M.V. "CLYDEFIELD"

PROPOSED ADDITIONAL FREEING PORT AREA.

FREEBOARD VERIFICATION FORM FOR STEAMERS.

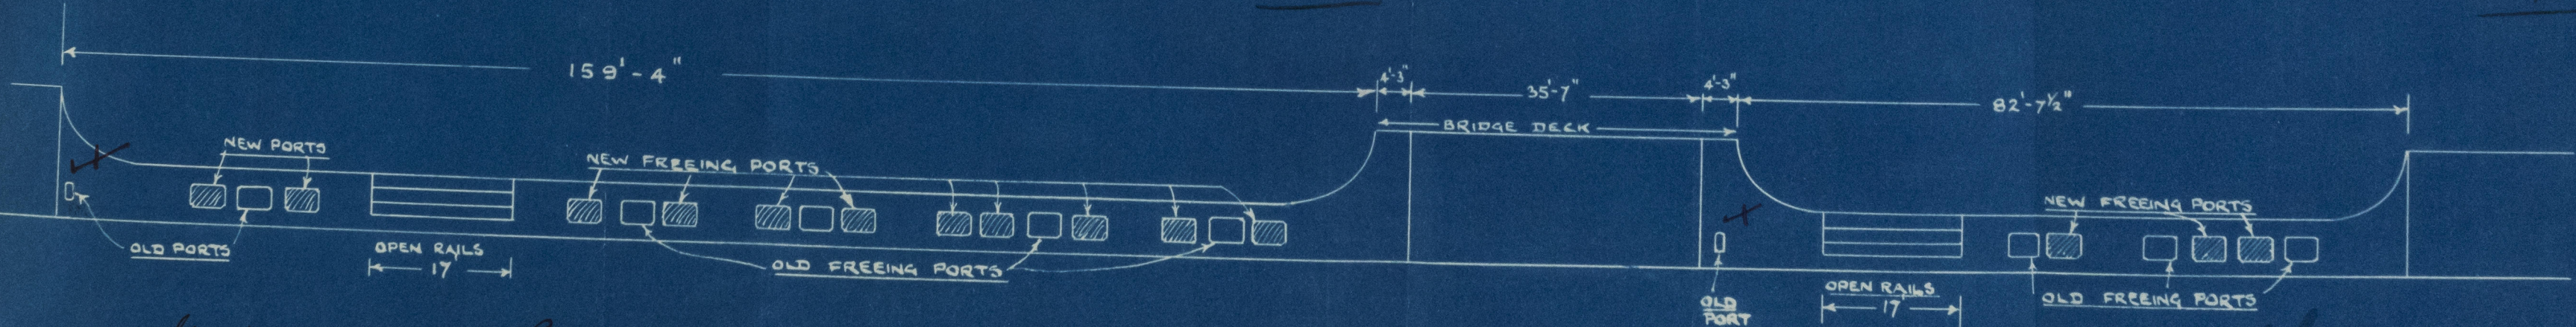
125.33 x 3.5' HIGH x 25% = 109.67 ϕ PORTS REQUIRED
FREEING PORTS 5 (OLD) @ 4' x 1'-9" = 5 @ 7 ϕ = 35.00 ϕ
1 (OLD) @ 1'-3" x 1'-3" = 1.56 ϕ
11 (NEW) @ 3'-10" x 1'-9" = 11 @ 67 ϕ = 73.70 ϕ

48.62 x 3.5' HIGH x 25% = 42.54 ϕ PORTS REQ.
FREEING PORTS 3 (OLD) @ 4' x 1'-9" = 3 @ 7 ϕ = 21.00 ϕ
1 (OLD) @ 1'-3" x 1'-3" = 1.56 ϕ
3 (NEW) @ 3'-10" x 1'-9" = 3 @ 67 ϕ = 20.10 ϕ

** It is assumed that these are freeing ports and not mooring pipes*

TOTAL AREA OF FREEING PORTS } 110.26 ϕ
1.56
108.70

TOTAL AREA OF FREEING PORTS 42.66 ϕ
1.56
40.90
